<b>Title - Sujet</b> Reconstruction quai Grande-Entrée	
<b>Solicitation No. - N° de l'invitation</b> F3731-170016/A	<b>Amendment No. - N° modif.</b> 003
<b>Client Reference No. - N° de référence du client</b> F3731-170016	<b>Date</b> 2017-12-04
<b>GETS Reference No. - N° de référence de SEAG</b> PW-\$QCM-008-17263	
<b>File No. - N° de dossier</b> QCM-7-40165 (008)	<b>CCC No./N° CCC - FMS No./N° VME</b>
<b>Solicitation Closes - L'invitation prend fin</b> <b>at - à 02:00 PM</b> <b>on - le 2017-12-13</b>	
<b>F.O.B. - F.A.B.</b> <b>Plant-Usine:</b> <input type="checkbox"/> <b>Destination:</b> <input checked="" type="checkbox"/> <b>Other-Autre:</b> <input type="checkbox"/>	
<b>Address Enquiries to: - Adresser toutes questions à:</b> Rochette, Jean	<b>Buyer Id - Id de l'acheteur</b> qcm008
<b>Telephone No. - N° de téléphone</b> (418) 649-2834 ( )	<b>FAX No. - N° de FAX</b> (418) 648-2209
<b>Destination - of Goods, Services, and Construction:</b> <b>Destination - des biens, services et construction:</b>

### AMENDEMENT 003

Title: THE DEMOLITION AND RECONSTRUCTION OF WHARVES 401 TO 405 OF THE FISHING HARBOUR OF GRANDE-ENTRÉE IN THE MAGDALEN ISLANDS, QC

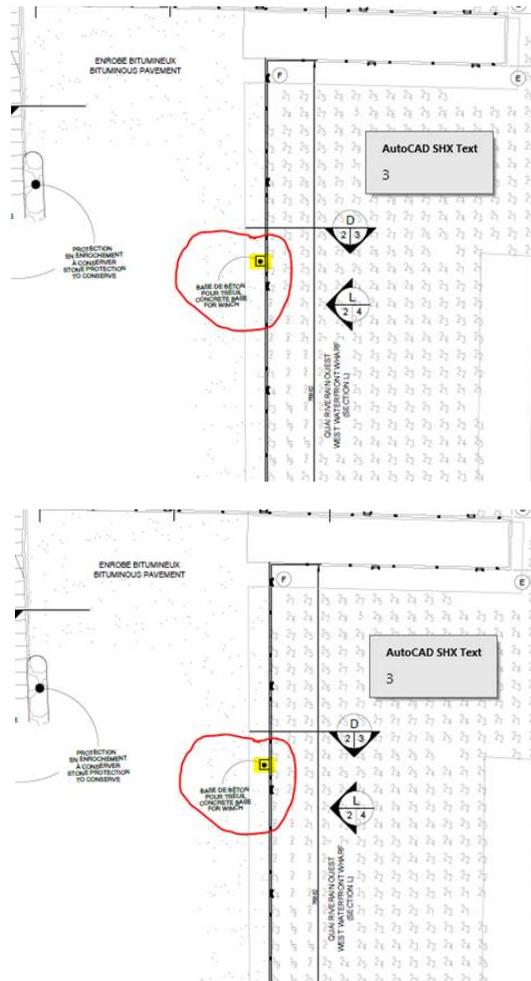
**Question 47:**

- A) For the following winch concrete base:
- Should we provide only the base?
  - Is the bolt product supplied?
  - The protector posts are included in which item to the tender form?
- B) There appears to be only one winch to be reinstalled, however, throughout the document there appear to be several. Can confirm the number of winches to reinstall?

**Answer 47:** One winch base to rebuild. Contractor shall supply bolts. Protector posts will be included in Item 7.3 – Services station.
